STAFF RECOMMENDATION

927 Gilmore Avenue

May 17, 2017

Application: New construction - addition

FRONT ELEVATION – SILHOUETTE STUDY

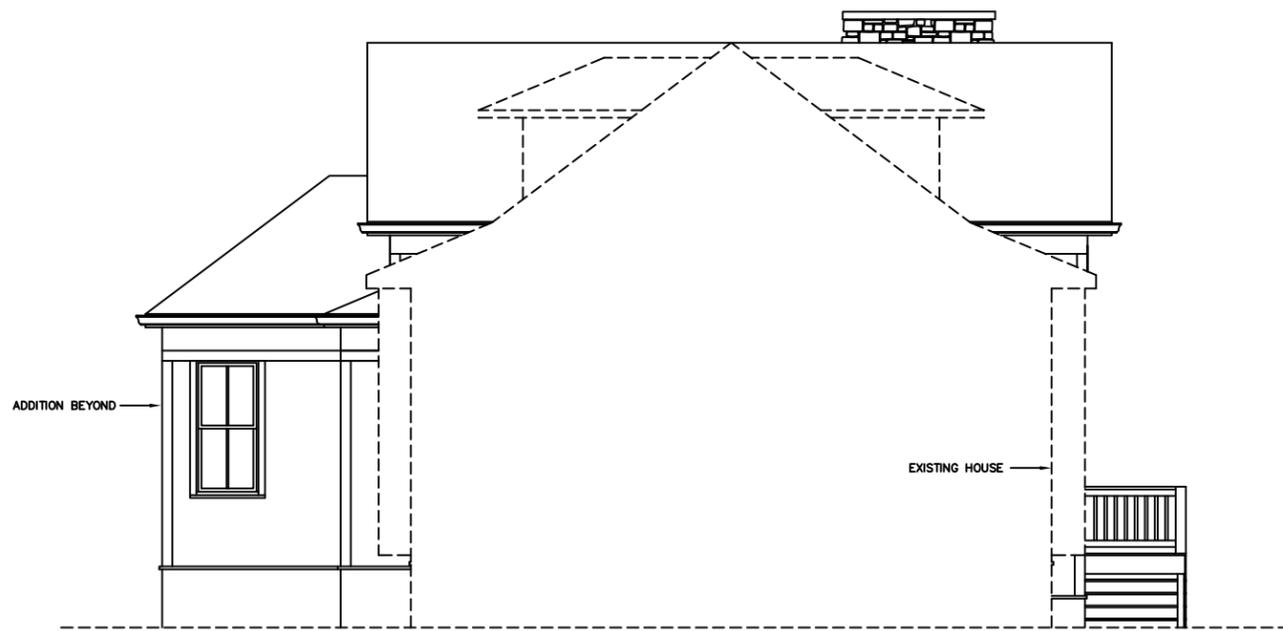
Roof form: The addition will tie into the existing roof with a gable ridge extending to the rear, intersected by a cross-gabled ridge matching the height of the existing roof peak. The primary eave height on the addition will also be lower than those on the existing house, with higher eaves only on the cross-gable component. The side slopes of the addition's ridge will have shed-roofed dormers on the left and right, behind the cross-gable and not visible from the right-of-way. The roofs of the cross-gable section extend outside of the "silhouette" of the existing house on the front elevation, but the gables are set well behind the existing building and do not impact the original form. The proposed addition is consistent with the form of several additions approved by the MHZC previously on houses with a similar roof form. Staff finds that the project meets section IV.C of the design guidelines for roofs of additions.

RIGHT SIDE ELEVATION

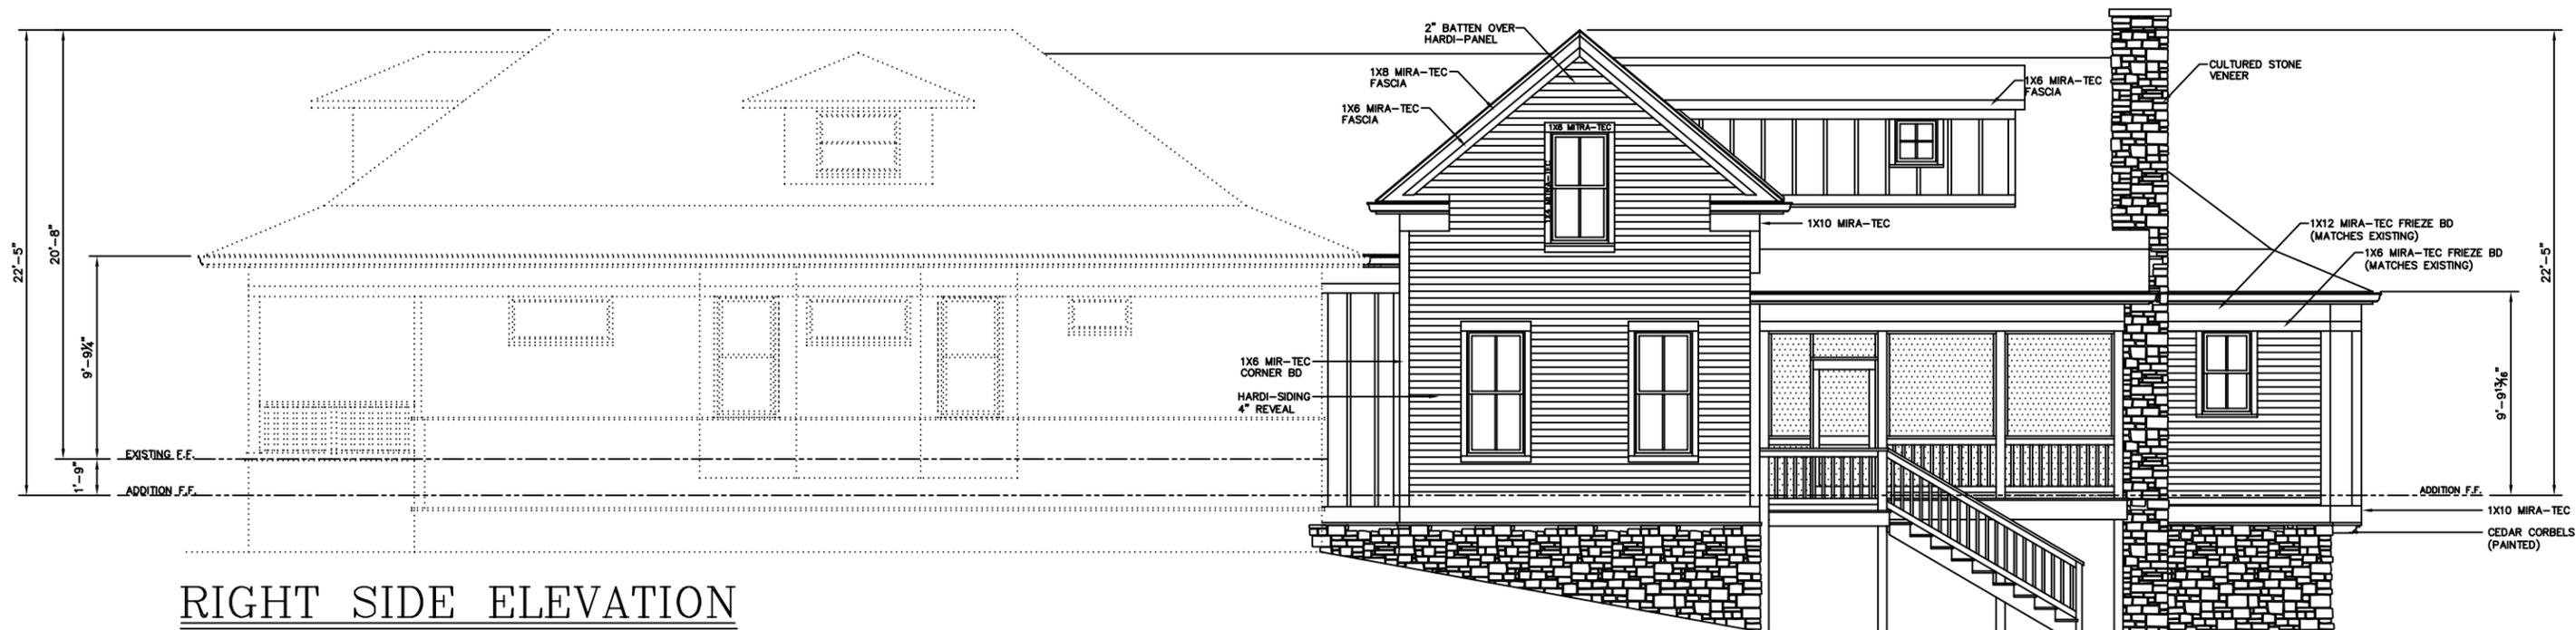
Height & Scale: The sides of the addition will be stepped in from the existing house with alcoves on both sides before stepping back out and continuing to the rear. The right side inset will be one foot (1') wide by three feet, six inches (3'-6") deep, before stepping out two feet, six inches (2'-6") to align with the side bay of the house and extending thirty-five feet (35') to the rear. The alcove on the left side will step in approximately five feet (5') and go eleven feet (11') back, then stepping back to match the width of the house, then ultimately stepping out eight feet (8') wider to the left. It is generally not appropriate for additions to be wider than an historic house unless the house is less than thirty feet (30') wide or shifted to one side of the lot. Although the middle of the house expands to thirty-two feet (32') where there are projecting bays the majority of the existing house is only twenty-eight feet (28') wide. The upperstory of the addition will match the width of the existing house. Staff finds the project meets section IV.B of the design guidelines for massing of additions.
